Access Compliance Report

Public Rights-of-Way

(Curb Ramps)

Intersection ID: 31610	Main Street: WINDY_VALLEY_DR	Cross Street: GUSTY_CT	Location: E
ADA ID: F9ED8678F8C2	Ramp Type: PerpDiag	Initial Pass/Fail: Pass	Overall Compliance: No
Codes/Mitigation Info/Possible Solution		Field Measurements/Component Compliance	
Severity Score: 17.75

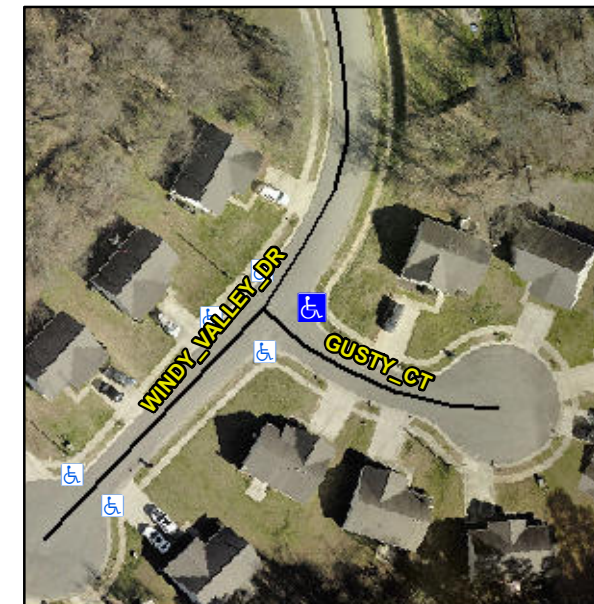
Not Found, R304.5.3, R304.2.1, R304.2.2-Perp, R304.3.2-Para, R305.1.4, R305.2, R302.7.2

Compliance	Description	Data	Compliance	Description	Data
N/A	Ramp Length (in)	50.0	Yes	Ramp Slope (%)	7.0
Yes	Ramp Width (in)	53.5	No	Ramp XSlope (%)	4.2
N/A	Flare Type LT	Sloped	N/A	Flare Type RT	N/A
N/A	Flare Slope LT (%)	2.9	Yes	Flare Slope RT (%)	7.3
N/A	Flare Traversable LT?	Yes	N/A	Flare Traversable RT?	Yes
No	Landing Length (in)	47.0	Yes	DWS Provided?	Yes
Yes	Landing Width (in)	52.0	Yes	DWS Contrast?	Yes
No	Landing Slope (%)	3.2	Yes	DWS Length (in)	24.0
No	Landing X Slope (%)	6.2	No	DWS Full Width?	No
N/A	Landing Curb? (Y/N)	No	No	DWS Offset (in)	3.5
N/A	Shared Landing?	No			
Yes	Gutter Ponding?	No	Yes	Gutter Slope (%)	1.0
No	Gutter Lip Ht (in)	1.5	No	Gutter X Slope (%)	3.4
N/A	Painted X Walk1?	No	N/A	Painted X Walk2?	No
	X Walk 1 Direction	To N		X Walk 2 Direction	To S
N/A	X Walk 1 Width (in)	N/A	N/A	X Walk 2 Width (in)	N/A
	X Walk 1 Slope (%)	5.5		X Walk 2 Slope (%)	4.4
	X Walk 1 X Slope (%)	3.8		X Walk 2 X Slope (%)	0.5

Remove & Replace Curb Ramp With Two New Directional Ramps or Equivalent. Remove & Replace Gutter.
